MESHESAT-1357, stream a1mech, 29 Sep 2026. Case frame: X east, Y toward the hinge (back) wall, Z up from the base floor, lid closed. mm. Prototype design, AI review: nothing built, bought or fitted; analytical success is not physical verification.

MeshSat field kit V2, Option A(i) lid pack: sheet A1-2 sections: the module under the ceiling over the face, at the worst room

MeshSat field kit V2, Option A(i) lid pack: sheet A1-3 the arrangements that fit, and the owner decision

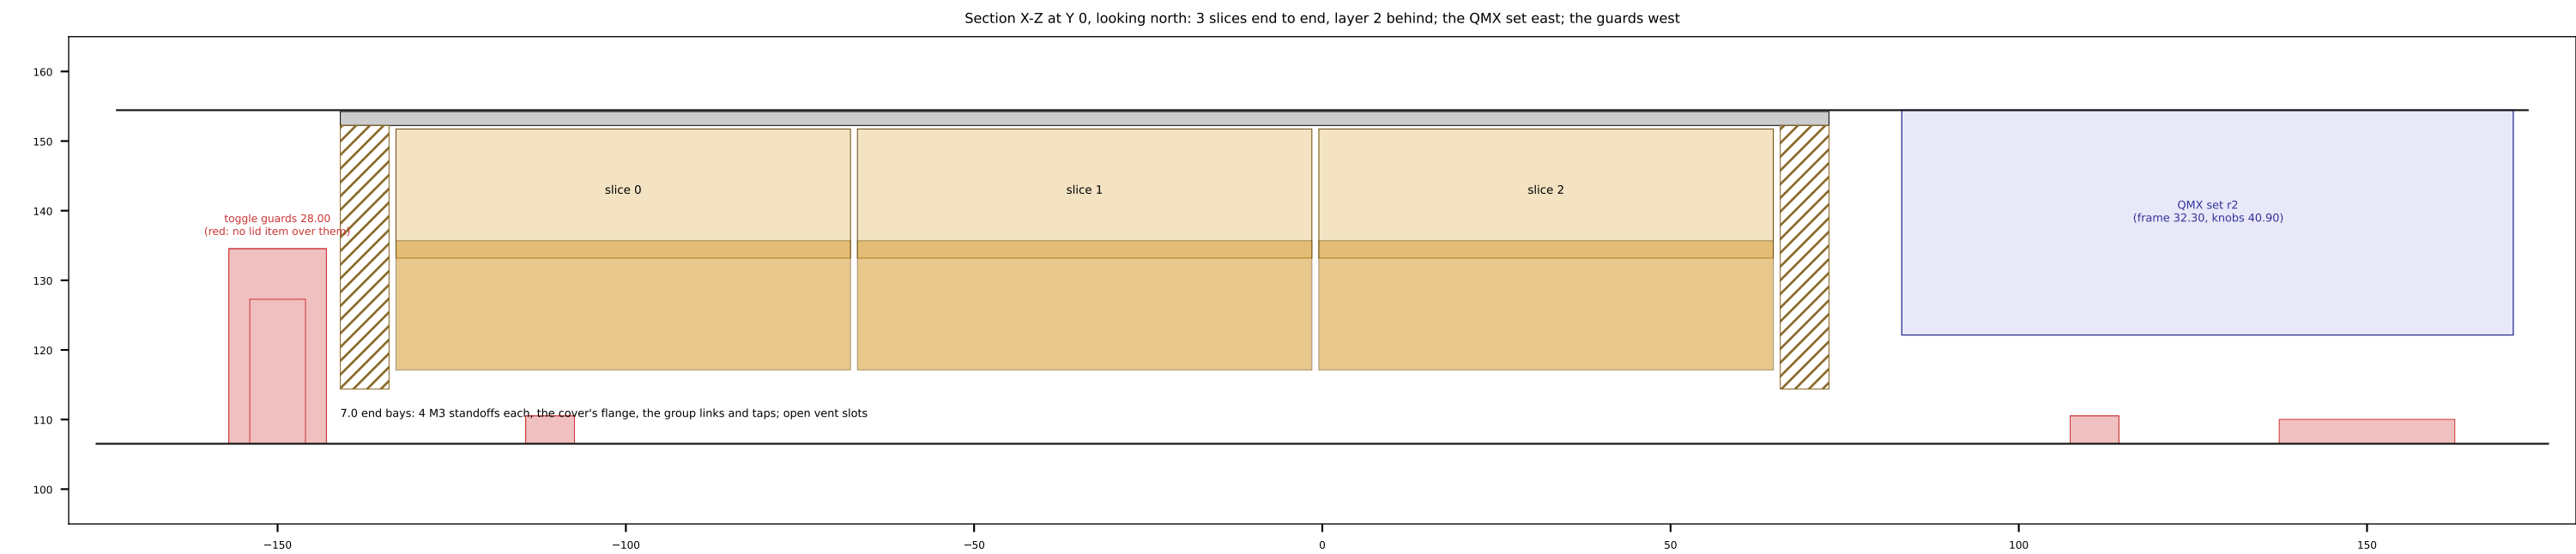
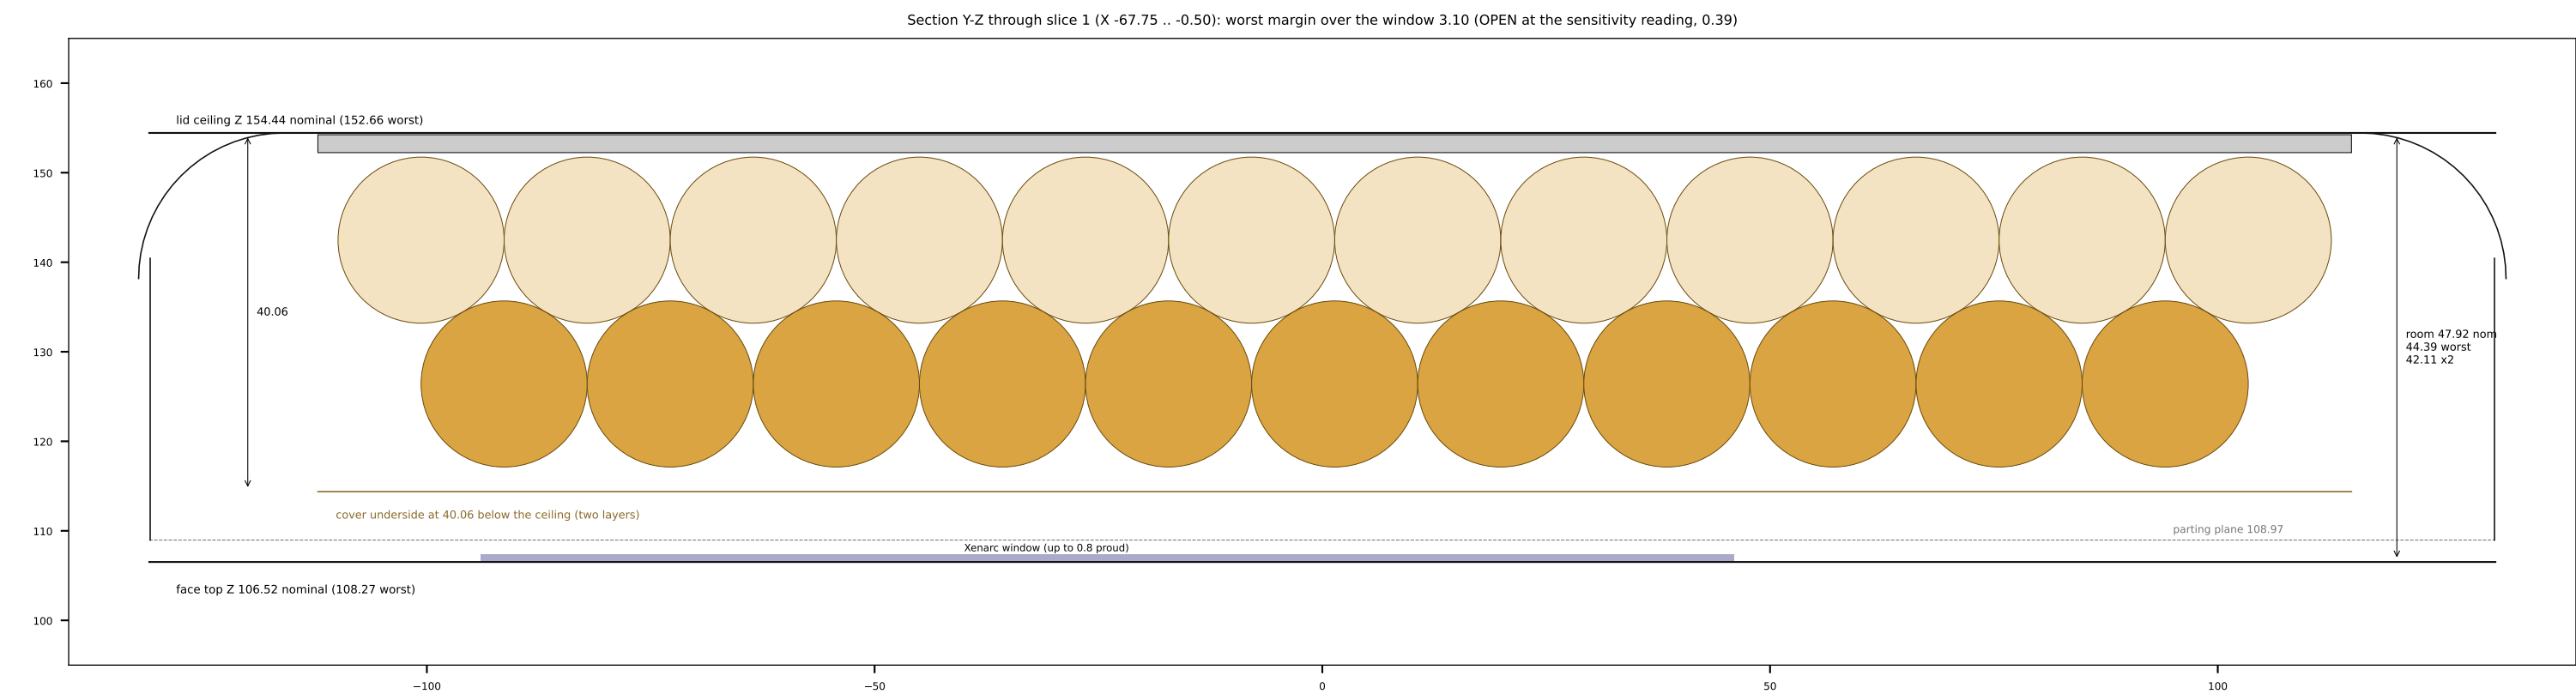
```
TIGTEST ROWS (worst, x2; min 1.0)
two layers over the Xenarc window 0.80: 3.10, 0.39 OPEN
two layers over the LED bar 1.50: 2.40, -0.31 OPEN
two layers over the e-paper lens: 3.85, 1.14 MET
one layer over the XFRAME screws: 15.96, 13.25 MET
layer 2 refused over XFRAME 1 and _3 (4.00): -0.10 worst
```

PLAN module to the QMX tray 10.45; inside the flat ceiling
1.00 in Y (the fillets begin at +.115.93)
west edge 2.0 from the toggle guard caps (X -143.0)
west slice stops north of the headset jacks (TBD)

OPEN AT THE MOCK-UP: T9 (chalk on the module's cover and the face parts, lid closed), T8 (pull test of a bonded plate on Peli's polypropylene), T-A1-1 to T-A1-4 of the README.

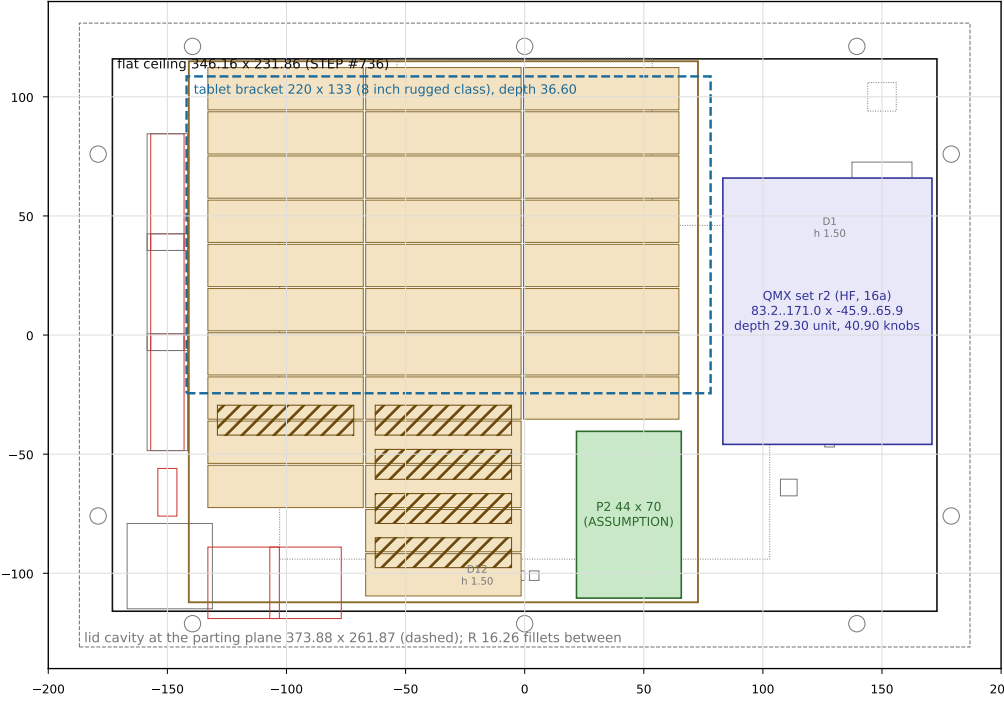
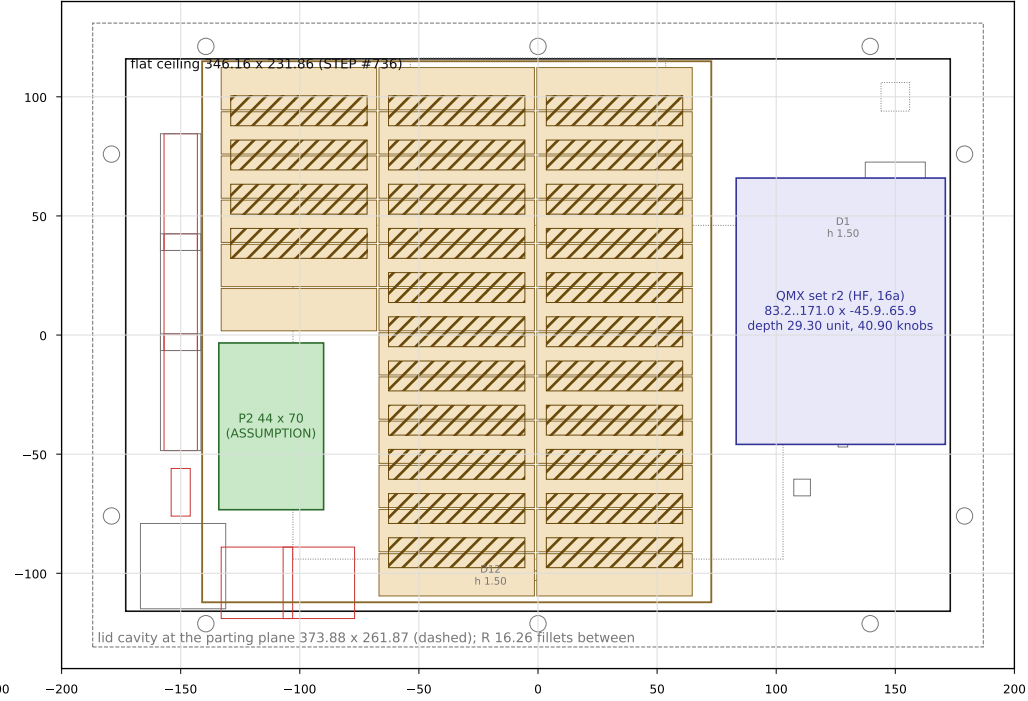
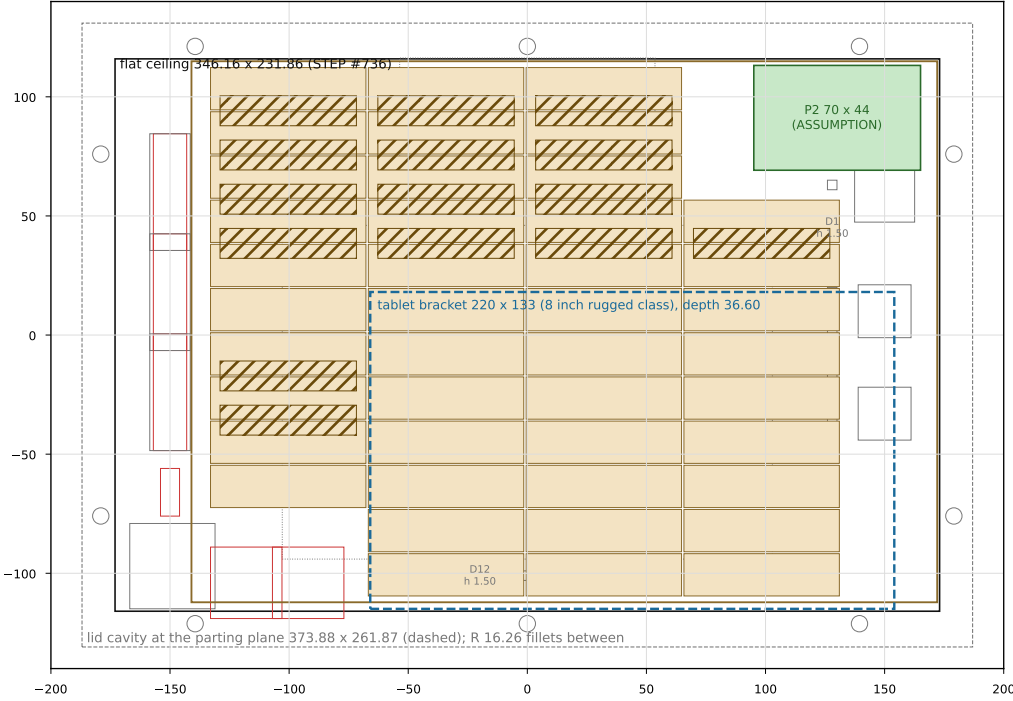
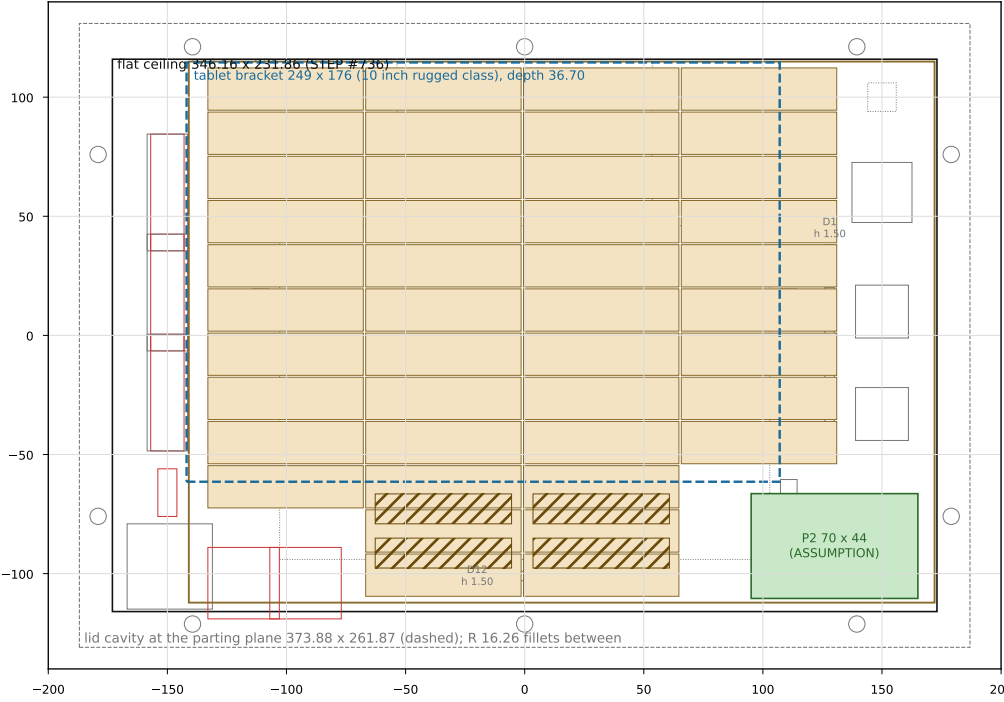
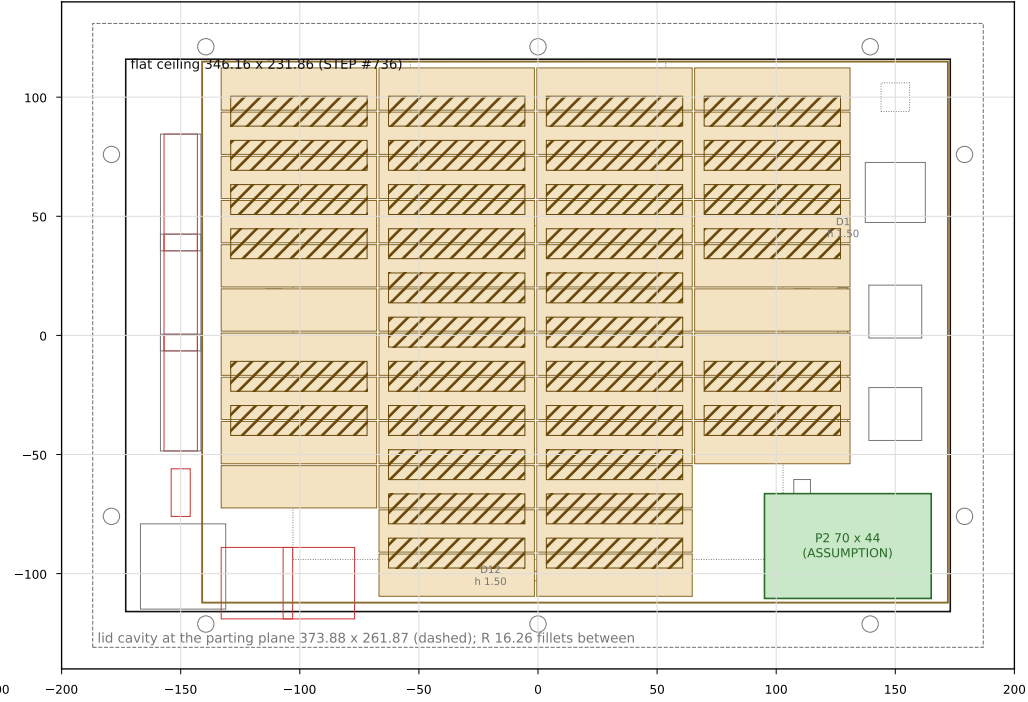
48 cells (4S12P) in the lid with BOTH the QMX HF set (16a) and the tablet bracket (16d): DOES NOT FIT. At the worst room the lid holds 35 places with both, 4S8P; the total 4S14P is under section 9c's 4S15P floor.

What fits 4S12P (each with every row of sheet A1-1 at or above its minimum at the worst):
1. HF kept, tablet bracket out of the lid: 56 places (4S14P); the tablet goes out of the case.
2. 8 inch tablet kept, HF (QMX) out of the lid: 58 places (4S14P); HF inside (16a) is lost: the base has no volume for the QMX set (section 8)
3. Both kept, lid pack 4S8P: not Option A(i); M1 not met on section 9's model

10 inch tablet: fits only with HF out: 47 places (4S11P). Both out: 77 places (4S19P).

Session's recommendation (engineering view only): option 1, which keeps a radio bearer and gives 8 spare places; the tablet works from outside the case on the kit's WiFi and USB-C outlet.

MeshSat field kit V2, Option A(i) lid pack: sheet A1-6 the base pockets: section 8's 4S6P at the same worst figures

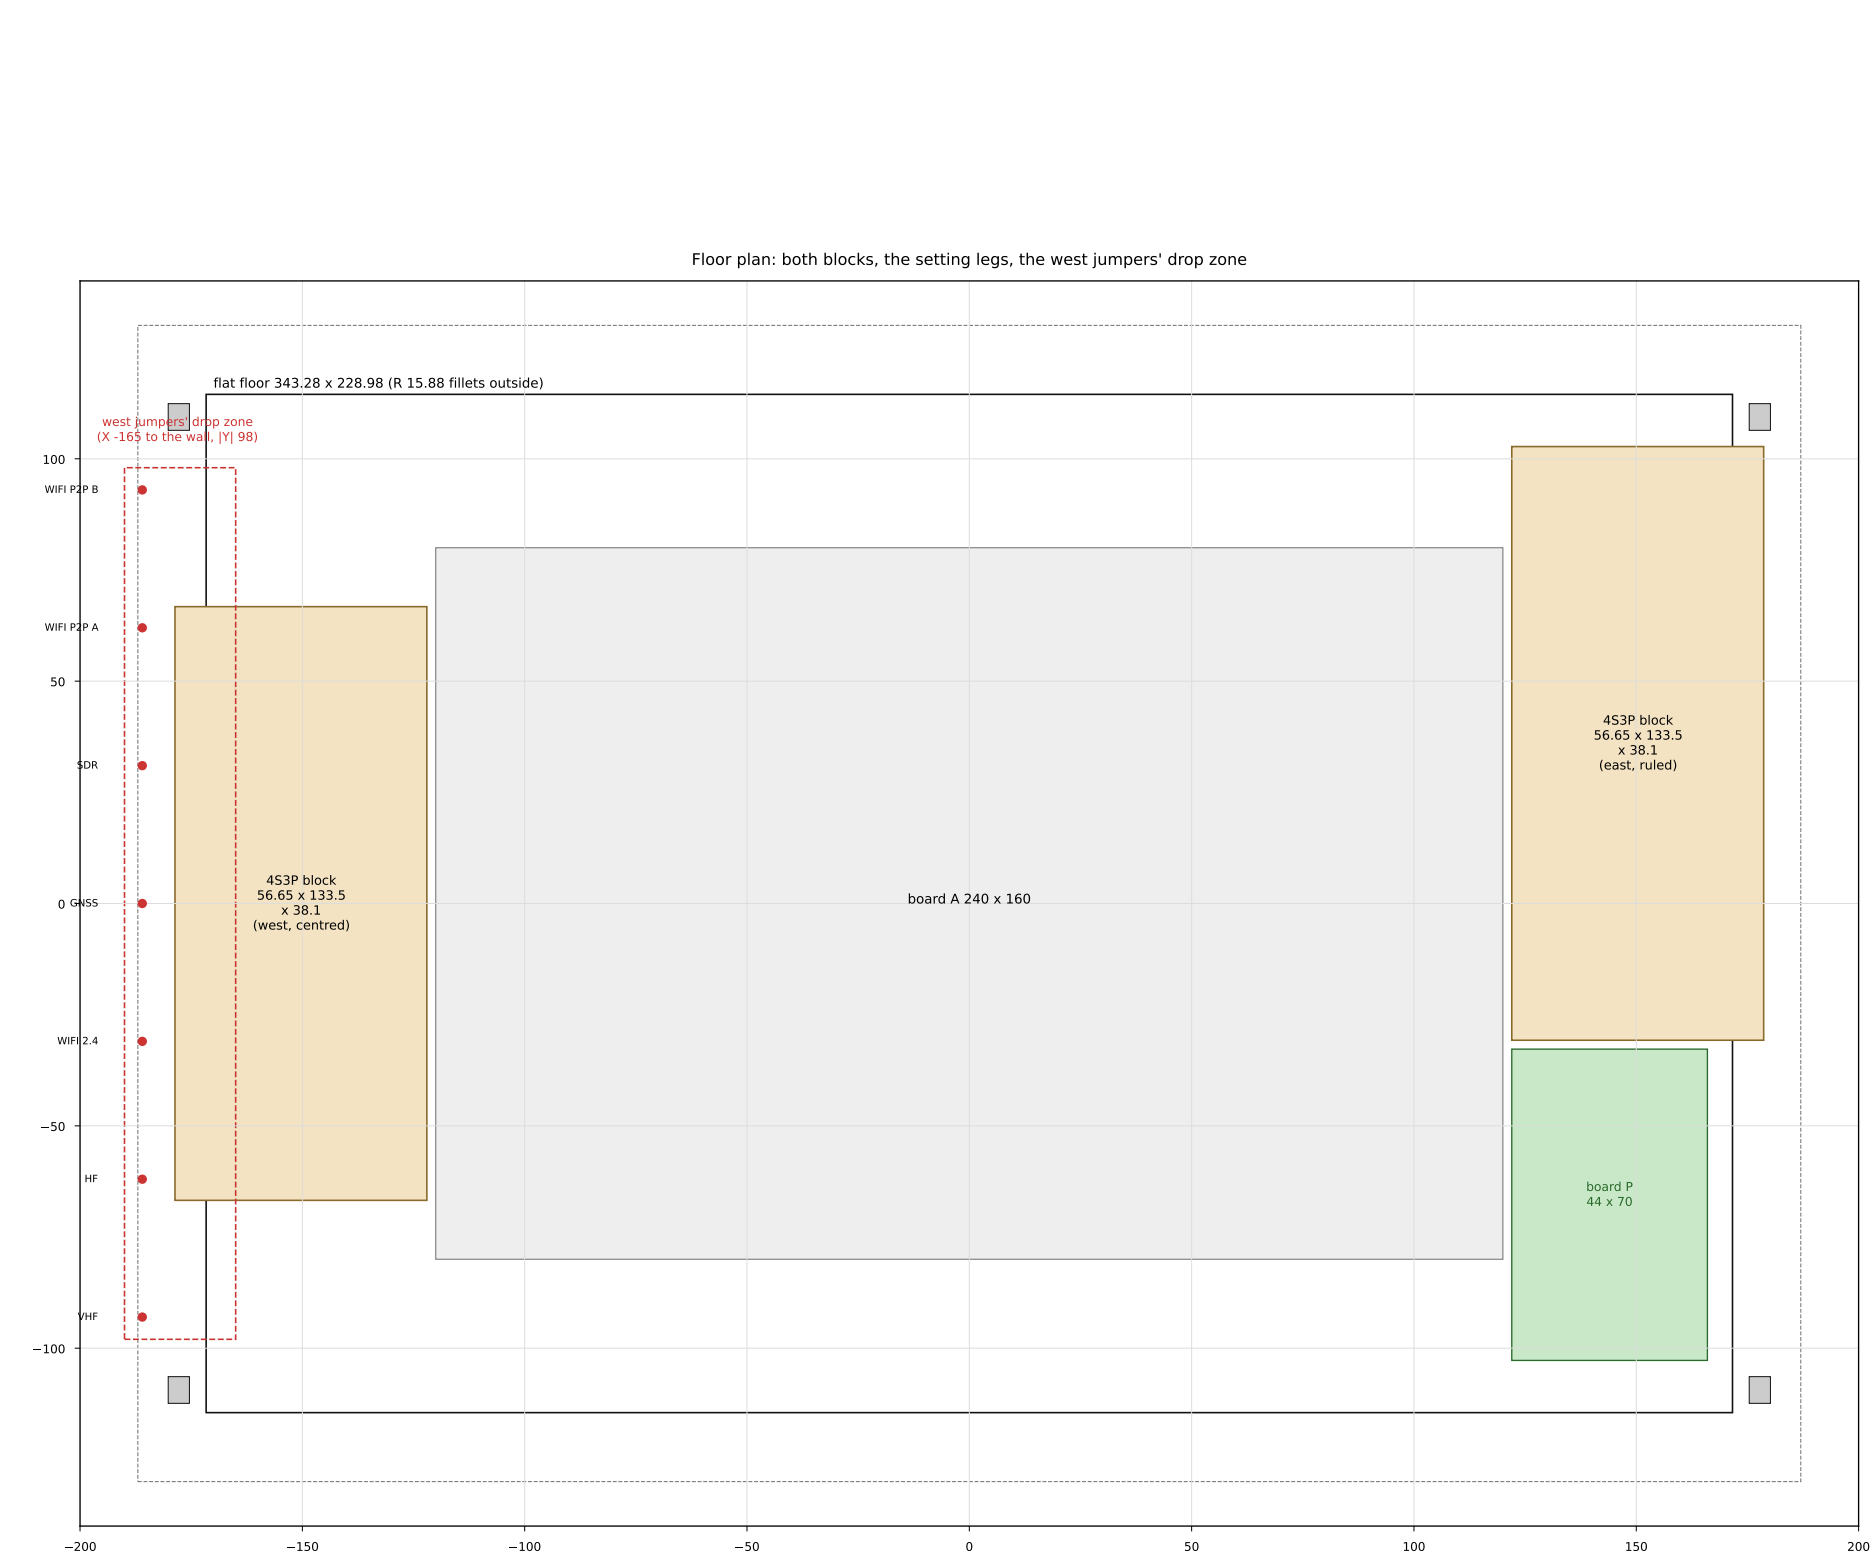
ROW	worst	x2	verdict
M4a	1.85	0.85	OPEN: placed by hand; T4
M4aw	1.85	0.85	OPEN: placed by hand; T4 (mirror: Peli's cavity and
M4b	7.38	6.38	MET
M4bw	7.38	6.38	MET (mirror: Peli's cavity and the RF entry plates a
M4c	3.18	1.80	MET
M4cw	3.18	1.80	MET (mirror: Peli's cavity and the RF entry plates a
M5	1.77	0.27	OPEN: placed by hand, the legs' locator; T4
M5w	37.77	36.89	MET (the block's Y place is not ruled; centred here)
M6	3.66	2.90	MET
M6w	3.99	n/a	OPEN: the x2 reading is not computed by A06's tool;

WEST RF JUMPERS: 5 of 7 west cables (Y -62, -31, 0, 31, 62) fall onto the west block; the slot over it is 7.19 at the worst less C33's zone (3.99); the only drop east of it is its 2.0 gap to board A, under one RG-316 (2.49): FAILS AS ASSUMED, held OPEN (section 8b, the M17 class): the west RF entry is re-planned before the west block is taken. Hold-down S-27 open for both blocks.
